Subject: Response to Notice of Deficiency: Voluntary Corrective Measures Work Plan,  
SS-61 Soil Remediation, August 2006, Holloman Air Force Base, EPA ID#  
NM6572124422, HWB-HAFB-05-007 and -008.

Response to Comments  
 Voluntary Corrective Measures Work Plan  
 Site SS-61 Soil Remediation, August 2006  
 Holloman AFB, NM

PROJECT NO.	SCALE	DATE	DRAWN BY:
9050361	1"=80'	12/19/06	cm
			DRAWING NO:
			Figure 1

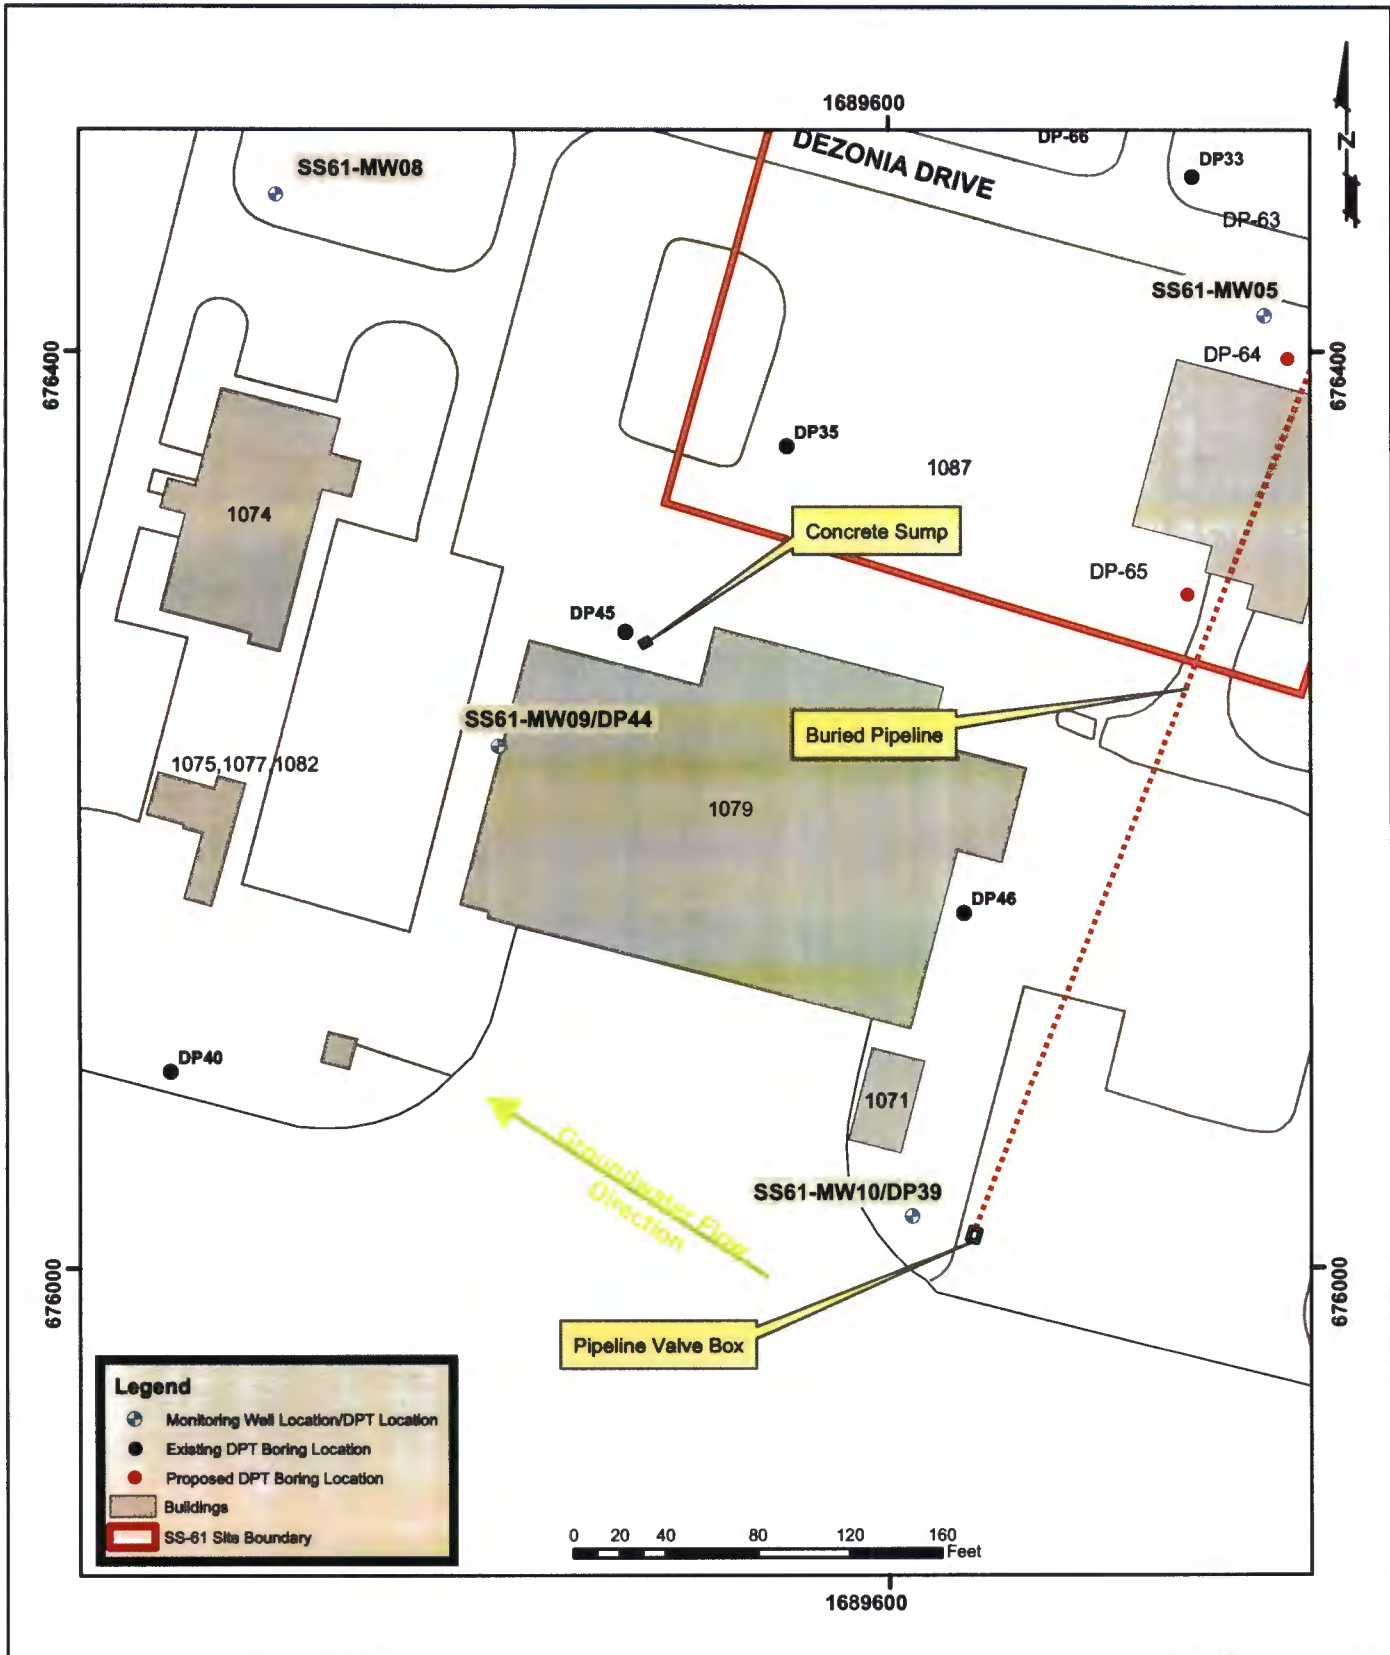
2	General		<p>According to Figures 1-3, 1-5, 3-1 and 3-2 in the Work Plan, the southern boundary for site SS-61 terminates north of Building 1079. However, various documents submitted for this site refer to the possible presence of an oil/water separator at the southeast corner of Building 1079 and a concrete sump located at the northwest corner of Building 1079. Section 5.4 (Summary of the Nature and Extent of Contamination) of the <i>Phase II Remedial Investigation Report for SS-61</i> (December 2000) states that gasoline-related constituents were detected in the groundwater south of Building 1079 and that these detections are likely the result of a past release from an oil/water separator formerly located at the southeast corner of Building 1079. In addition, a soil sample collected from 1-2 ft below ground surface in boring DP-40, collected during the Phase II Remedial Investigation</p>	<p>The <i>Phase II Remedial Investigation Report for SS-61, Holloman AFB, NM</i> (Foster Wheeler, 2000) references a concrete sump located near the northwest entrance of the hangar (B1079) and a oil/water separator located near the southeast corner of Building 1079. . A site visit was conducted on December 14, 2006 to investigate the concrete sump and the oil/water separator associated with B1079. As determined during the site visit the locations of the two structures are shown in the attached Figure 1. The metal lids covering each structure were removed so that the interior could be inspected and photographed.</p> <p>As shown in attached Photographs 1 and 2 it was determined that the oil water separator described in the Phase II RI Report is actually a valve box for the buried underground pipeline that traverses Site SS-61 from the north to south (Figure 1). Based on the location of the pipeline valve box (located 94 ft from the southeast corner of B1097), the southern extent of the buried pipeline is located approximately 50 feet</p>

Comment No.	Section	Page	Comment	Response
Author	David Strasser		Date of Comments: November 27, 2006, Notice of Deficiency HWB-HAFB-05-007 and HWB-HAFB-05-008	Date of Response: December 20, 2006
			<p>in May 2000, showed a Total Petroleum Hydrocarbon (TPH) result of 7,800 mg/kg. This boring is located just southwest of Building 1079.</p> <p>The NMED's January 27, 2006 NOD for the <i>Monitored Natural Attenuation Report for SS61</i> (Comment #2) required that the Permittee submit a discussion on the possibility that the two aforementioned structures near Building 1079 could be a potential source of groundwater contamination at this site and to include a figure depicting the locations of these structures. This comment was not addressed in the Work Plan.</p> <p>The Permittee is again required to submit this discussion and figure and to explain why the southern boundary of SS-61 does not extend to a point south of Building 1079.</p> <p>Regarding the elevated TPH soil sample result from boring DP-40, the Permittee is required to revise the additional investigation requirements of the Work Plan to include additional soil characterization for hazardous constituents in the vicinity (within 20 to 50 feet) of boring DP-40 to determine if this area is a potential source of groundwater contamination.</p>	<p>southeast from what is depicted on Figure 3-1 (SS-61 Voluntary Corrective Measures Work Plan, Bhate, 2006). As a result, Figures 1-3 and 3-1 from the Work Plan, (attached) have been revised to show the actual location of the buried north-south trending pipeline.</p> <p>The concrete sump (attached Photographs 3 and 4) is located approximately 20 feet from the northwest entrance of B1079 (Figure 1). Based on interviews with current B1079 personnel, 6 to 8 floor drains located throughout B1079 were connected to the concrete sump. The sump gravity drained into the sanitary sewer system. It was reported during the site visit that the B1079 floor drains were sealed with cement approximately two years ago.</p> <p>During the Phase II RI (Foster Wheeler, 2000) a total of 40 soil samples were collected from 20 direct push technology (DPT) borings drilled within in the southern portion of SS-61 (south of Dezonion Rd) in the vicinity of B1079 and B1080. As shown in the attached Figure 1, four DPT soil borings were drilled adjacent to the northwest and southeast corners of Building 1079. DPT borings DP44 and DP45 were drilled along the northwest corner of B1079 down and cross gradient from the concrete sump. DPT borings DP39 and DP46 were drilled adjacent to the southeast corner of Building 1079 downgradient of the pipeline valve box. These borings were advanced to approximately 20 ft below ground surface; three soil samples were collected from each borehole for vertical characterization.</p> <p>TRPH was detected in DP-39 in the 1- to 2-ft interval at a concentration of 260 mg/kg. TRPH was also detected at DP-44 in the 11- to 12-ft interval with a concentration of 46 mg/kg. Both of these detections are below the NMED SSLs for TRPH. Additionally, TRPH and VOCs were not detected in any of the other soil samples collected from these</p>

Comment No.	Section	Page	Comment	Response
Author	David Strasser		Date of Comments: November 27, 2006, Notice of Deficiency HWB-HAFB-05-007 and HWB-HAFB-05-008	Date of Response: December 20, 2006
				<p>four soil borings. Therefore, based on the analytical results from the Phase II RI, there does not appear to be source area associated with either the concrete sump or the pipeline valve box.</p> <p>Additionally, Section 5.4 in the Phase II RI Report stated that "Only one soil sample collected during the Phase II RI exceeded the petroleum hydrocarbon action level. TRPH was detected at a concentration of 7,800 mg/kg at DP40 in the sample collected from 1 to 2 ft." The location of DP40 is also shown on the attached Figure 1. It is important to note that TRPH and VOCs were not detected in the two DP40 samples collected from 5 to 6 and 8.5 to 9.5 ft bgs.</p> <p>In April 2004, as part of the Focused Feasibility Study, eight soil samples were collected from four locations in the area surrounding the Phase II RI sampling location DP-40. The boring locations and sampling results are shown on Figure 3 of the <i>Interim Final Focused Feasibility Study, Spill Site 61, Holloman AFM, NM</i>, (Bhate, 2004). The four soil borings were field located approximately 10 feet to the north, south, east and west of soil boring DP-40. Two soil samples were collected from each location (one sample from 0 to 1 foot, and one sample from 1 to 2 feet) and analyzed for TRPH and total organic carbon. Values for TRPH ranged from non-detect to 201 mg/kg in the sample from SB-02-1, collected from 0 to 1 foot. TRPH detected in each soil sample was in the C22-C36 carbon range. TRPH was not detected above the NMED total petroleum hydrocarbon screening level of 940 mg/kg (TPH screening guideline for kerosene and jet fuel, NMED October, 2006). Therefore, this isolated occurrence of petroleum hydrocarbon (DP40 1 to 2 ft bgs) is likely the result of an isolated surface spill in the area.</p> <p>Based on the soil data collected during the Phase II RI and the</p>
